Environmental Review Team Report

Minor - Brown Subdivision

Andover, Connecticut

April 1981

ALTERNATE SITE PLAN

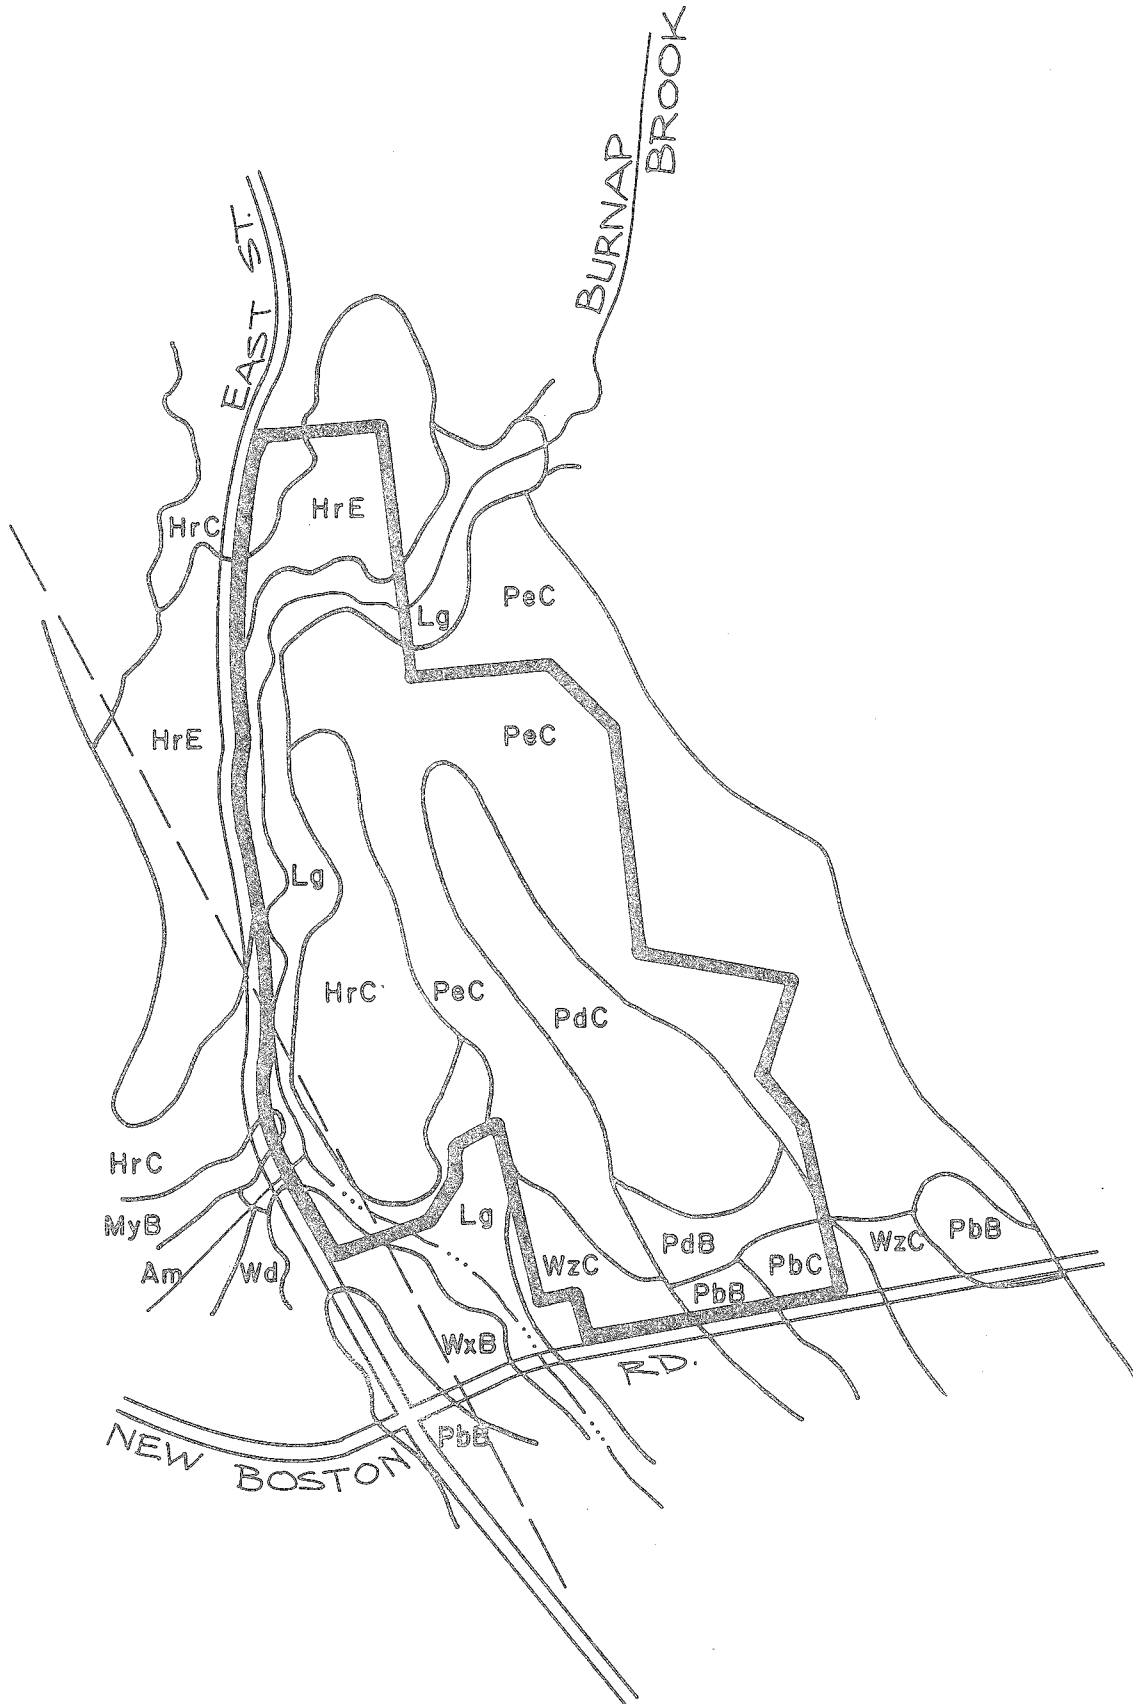
This site has a number of natural features and resources which could guide a development plan somewhat differently. These features include Burnap Brook and associated wetlands, shallow to bedrock soils and rock outcrops, a natural drainage way in the northwestern portion of the site and a rather flat ridge with deep Paxton soils along the eastern portions of the site.

By identifying these features on a map, a configuration could be developed which includes 18 lots of varying acreage; shallow to bedrock soils can be avoided, the natural drainage way can be avoided, Burnap Brook and wetlands crossed one time, driveways kept shorter and laid on the contour as much as practical. This configuration could maximize use of the deeper Paxton soils and the flatness of the ridge which extends generally north to south. Potential erosion and sediment problems would be minimized by this type of development pattern.

A development plan such as this would require an interior road connecting to East Street and Boston Hill Road, a distance of approximately 3,500 feet. Set back lines of 75 feet could be maintained and lots could probably average 3.5 acres.

The major advantages would include preservation of Burnap Brook and retention of the streambelt corridor including its wetlands. Avoiding development on shallow to bedrock soils, fitting homes, driveways and septic systems to the soils and topography, minimizing driveway lengths and steepness of grade, minimizing erosion and sedimentation on the site, preserving fish and wildlife habitat values, and allowing for interior road construction on the contour. All lots could be sited so that surface drainage is away from the houses, and all houses could be above the road elevation.

The major disadvantages are the costs of the interior road construction, and the irregular shape of some lots. While the interior roadways would be expensive, some of that cost would be offset by fewer bridge crossings and shorter driveway lengths. There is now approximately 8,000 feet of driveway needed. That amount could be reduced to about 4,000 feet.
